Subject: Aquatic Land Lease No. 20-A85592 Dave Ullin Open Water Marina Redesign Plans

Dave Ullin Open Water Marina Redesign Plans

Open Water Marina Redesign Approval Letter July 11, 2019

Proposed Buoy Layout and Vessel Sizes

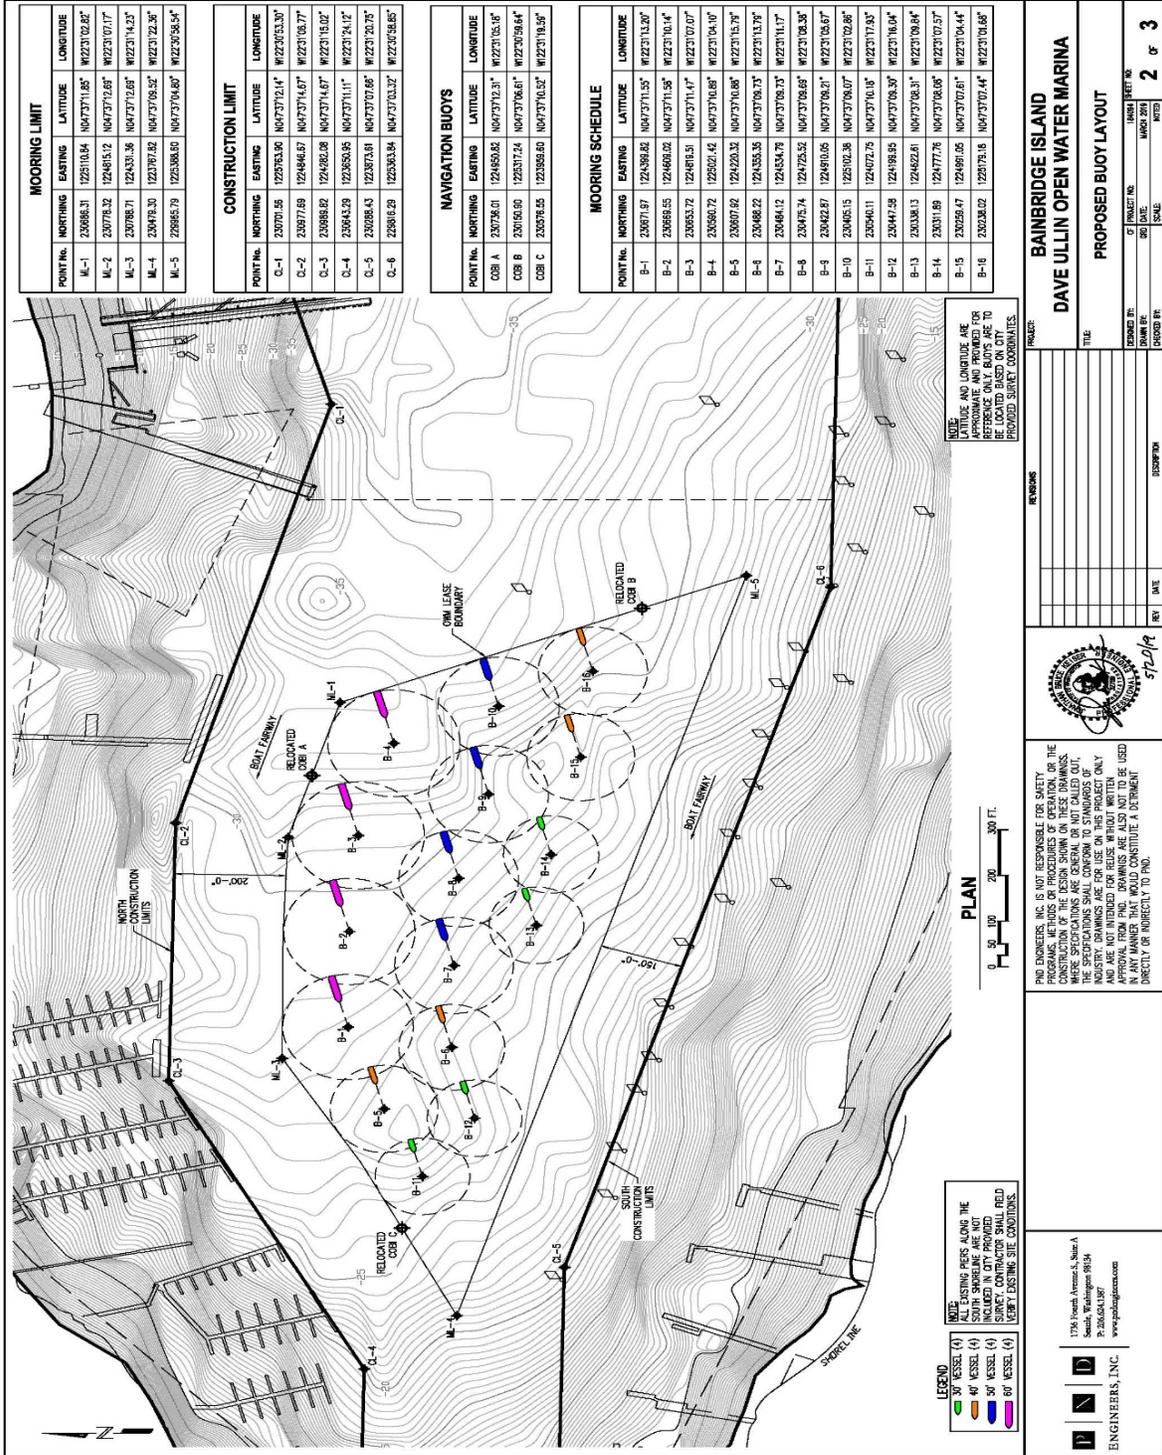
- 16 new mooring buoys with helical anchors and midline floats will be installed to provide for a total number of 16 liveaboard vessels with a maximum length of 60 feet.

- All liveaboard vessels will be on single-point moorage with all vessel swing circles located within the leasehold boundaries.
- Four new mooring buoys will be dedicated to each of the four vessel sizes: ≤ 30 ft, ≤ 40 ft, ≤ 50 ft and ≤ 60 ft lengths.

- New mooring buoys will be labeled with a buoy identification number and a designated vessel length.
- The spacing of new mooring buoys will provide for an approximately 75 ft wide fairway at the southern end of the Open Water Marina for navigation purposes.

- To accommodate this fairway the proposed layout of each of the buoy incorporates a swing radius of 10 percent overlap with the neighboring buoy swing radius. This minor overlap of vessel swing circles accommodates the highest density of mooring vessels within the leasehold and optimizes all adjacent navigation channels.

- City of Bainbridge Island contractor PND Engineers, Inc. provided a technical memorandum stating that a moored vessel collision will be avoided because vessels move and reorient equally with currents, wind, waves, and tidal fluctuations. They also provided the swing radius for each mooring buoy will be approximately 180 percent of the extreme low tide (ELT) swing radius (i.e., ELT is when there will be the most slack in the anchor line).

- If a vessel collision does occur due to the minor swing circle overlap, the City of Bainbridge is required to review and readjust vessel size assignments on mooring buoys to ensure any future collisions could not occur.

- The work meets the redesign specifications detailed in the project summary and your project plans as represented in Attachment A, enclosed.
- The work is done in accordance with all associated local, state, and federal permits.
- The work conforms to all other existing terms and conditions of your lease.
